PRIORITY DEVELOPMENT PROJECT STORM WATER QUALITY MANAGEMENT PLAN FOR VISTA II

Revision Page

February 14, 2024

This PDPSWQMP presents a revision to the October 16, 2023 report pursuant to the County of San Diego plan check comments received January 24, 2024. The following text identifies the plan check comments along with the responses in bold.

VISTA II
BMP-A1/A2 CONFIGURATION
VAULT TO PROPRIETARY BIOFILTRATION

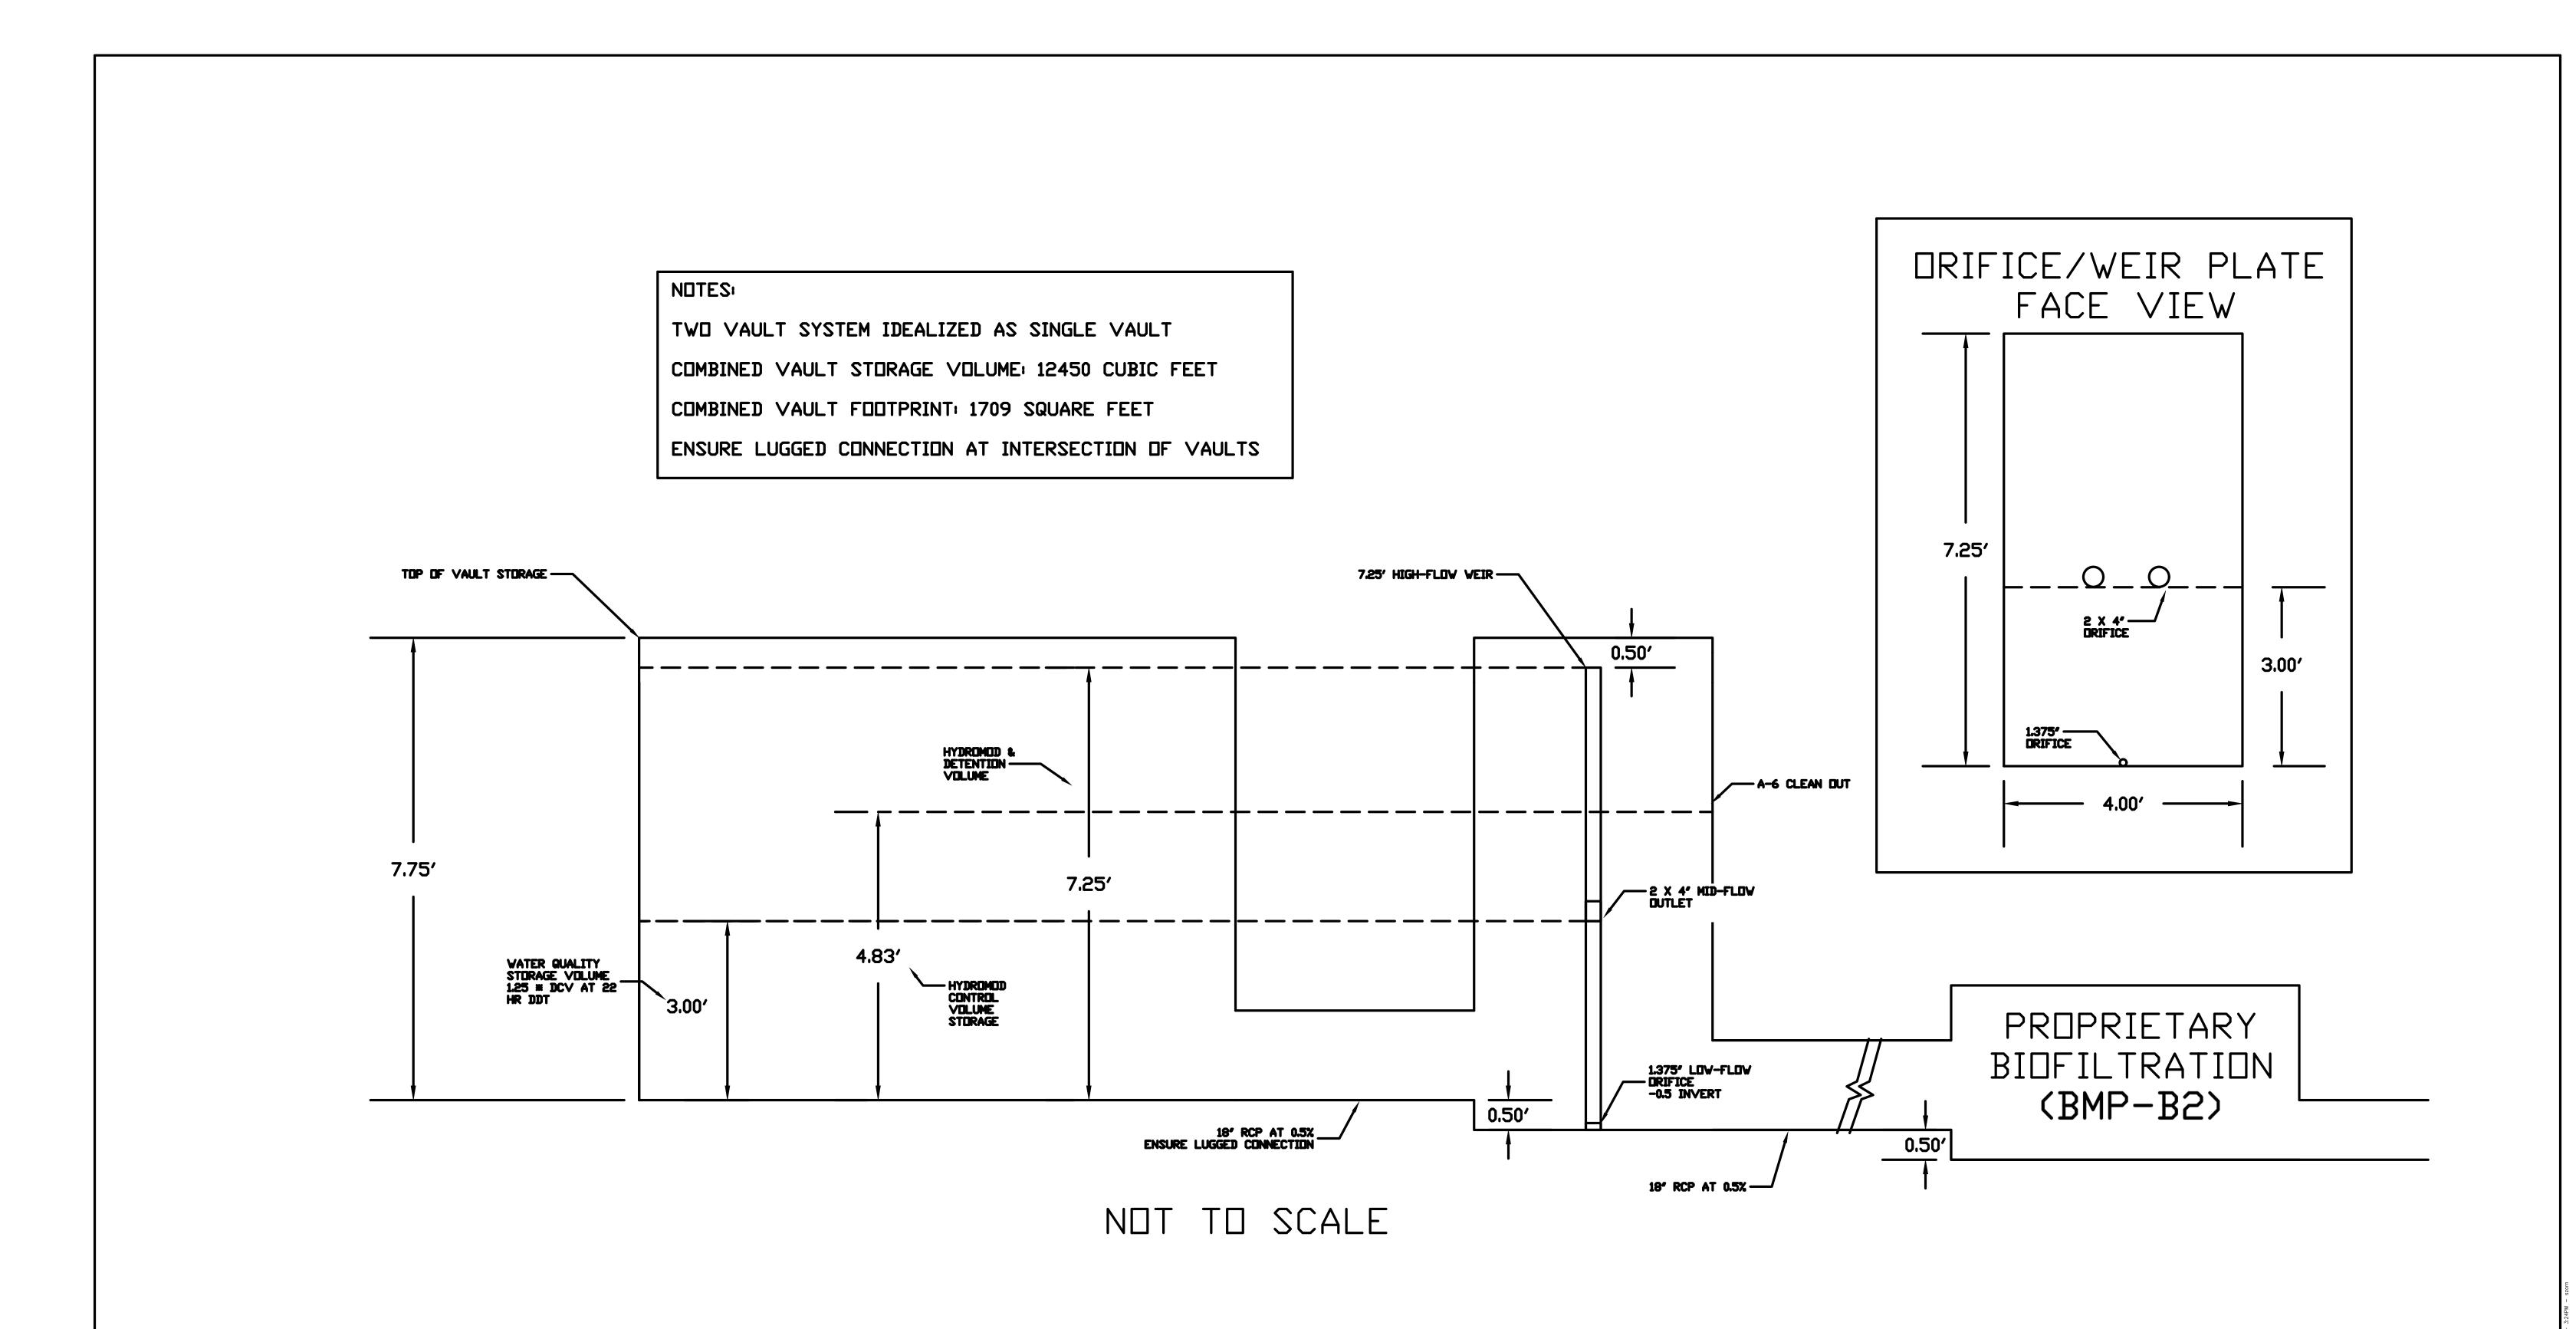
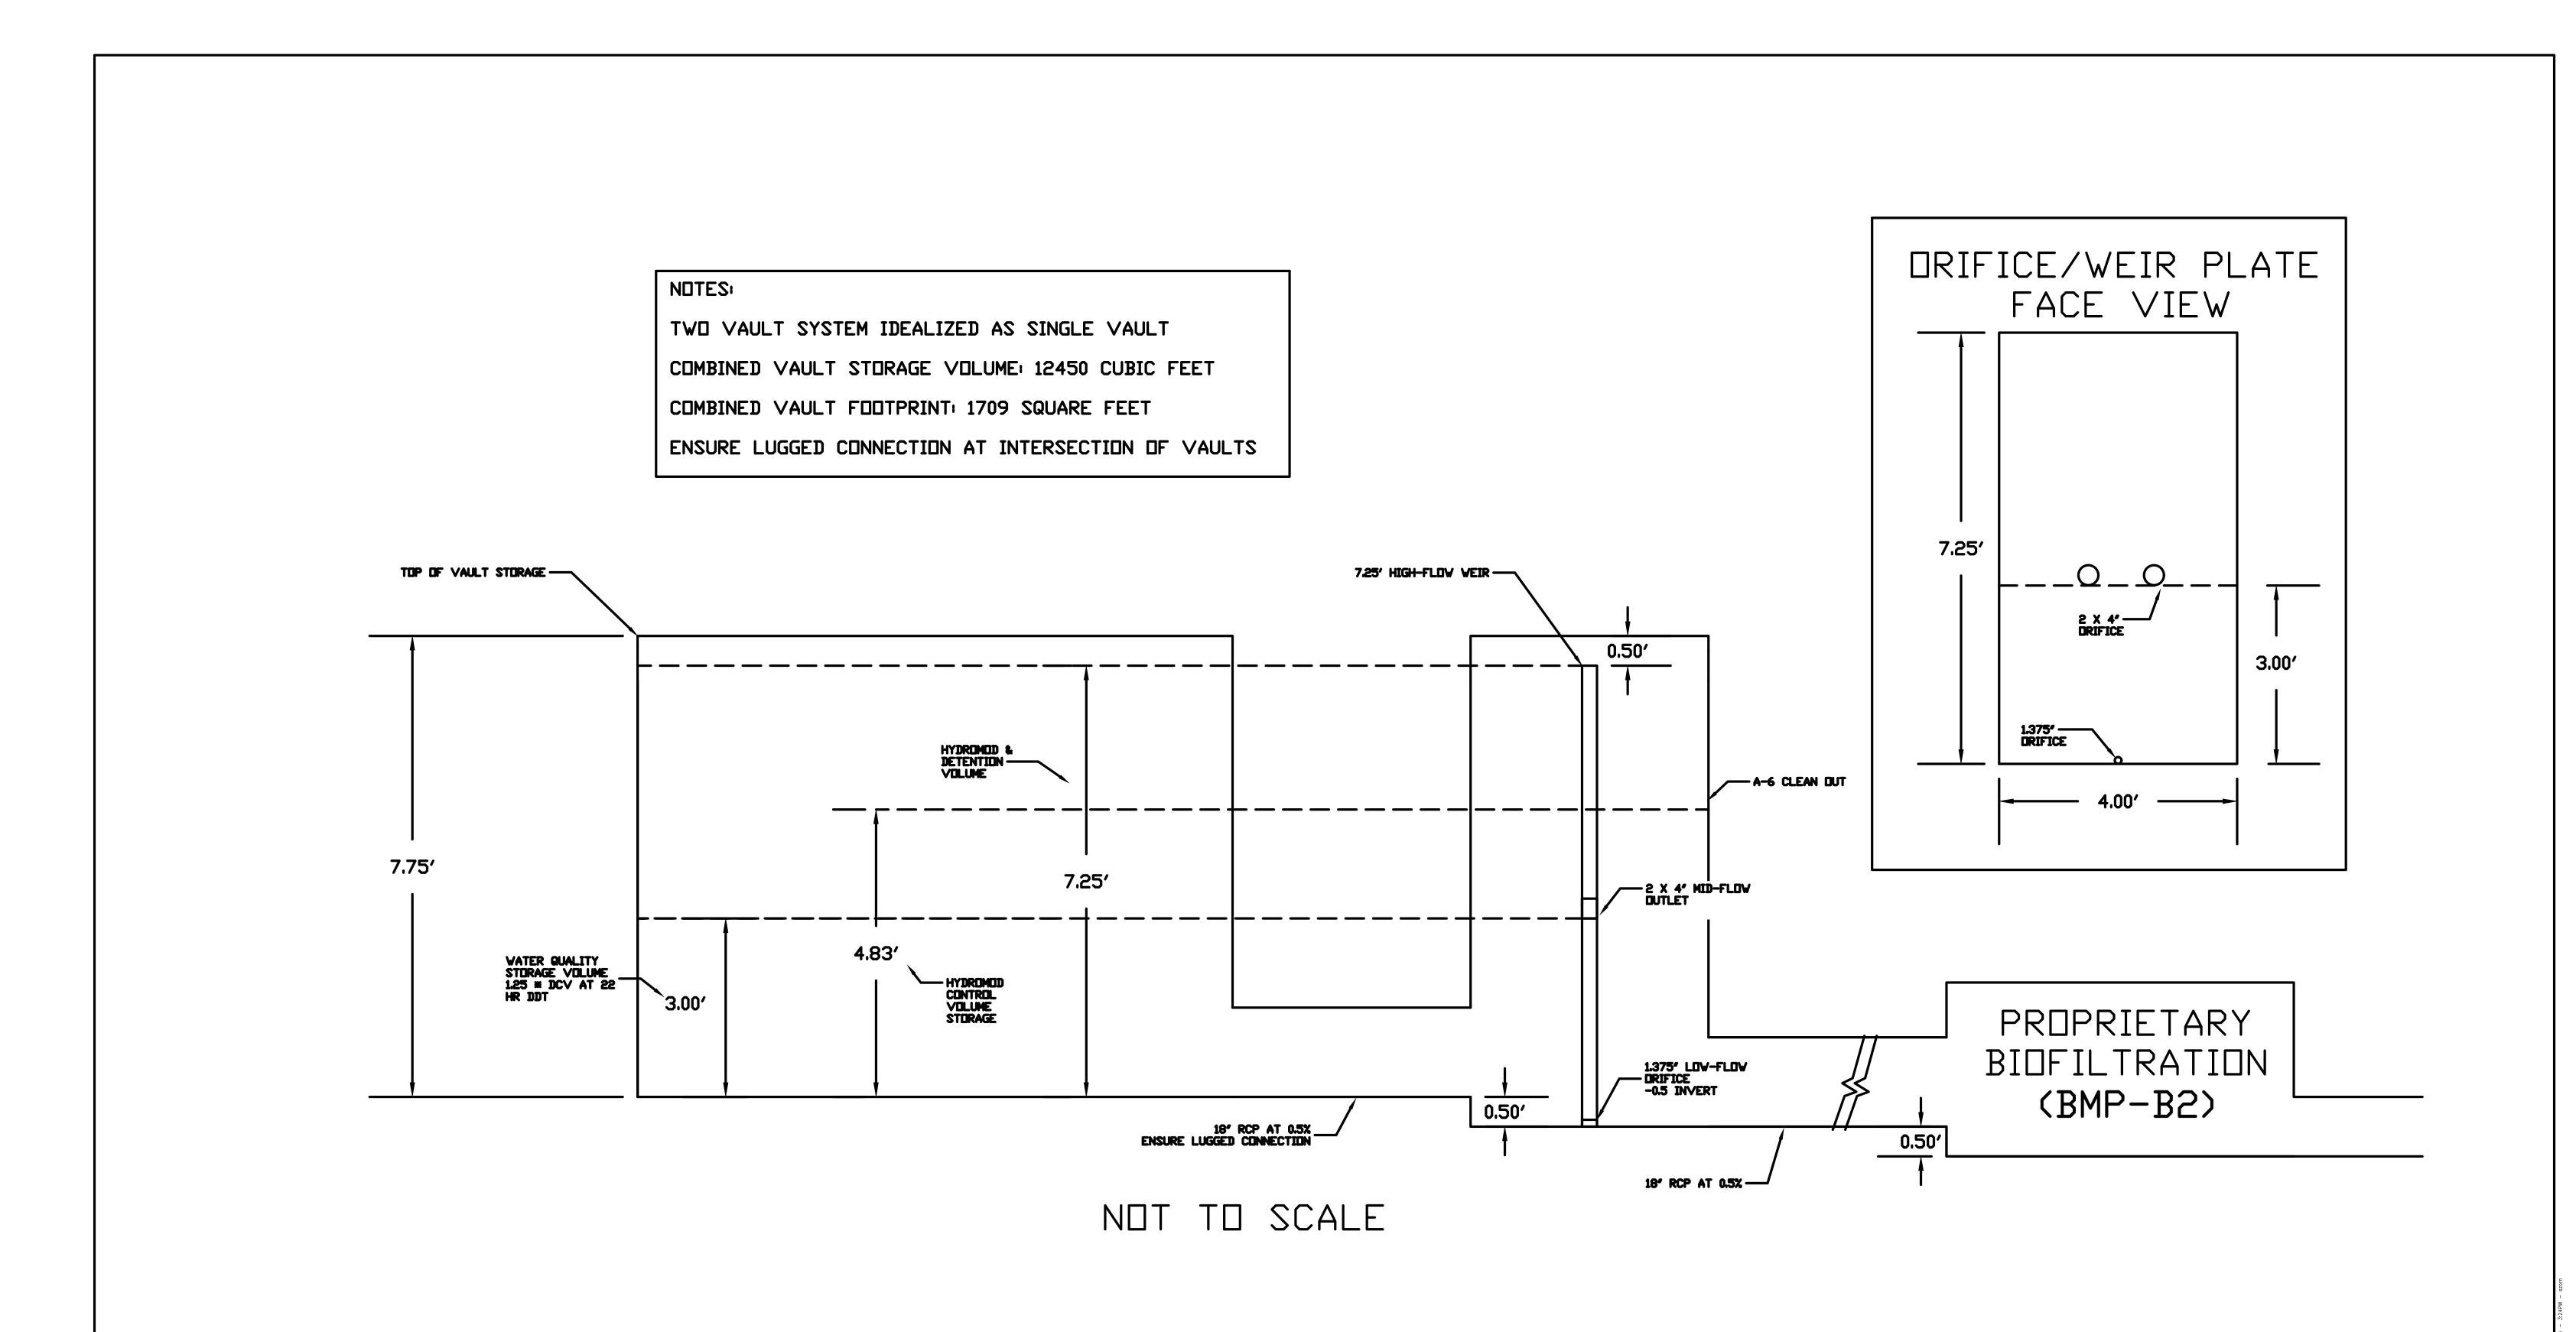
6-25c. Indicate the orifice/weir plate width in the face view provided in Vista II BMP-A1 Vault to Proprietary Biofiltration sheet.

The design of the outlet works has been changed to outlet structure inside the vault. This configuration makes it impractical to show an orifice/weir plate equivalent. However, elevations, diameters, and number of orifices have been called out in this detail.
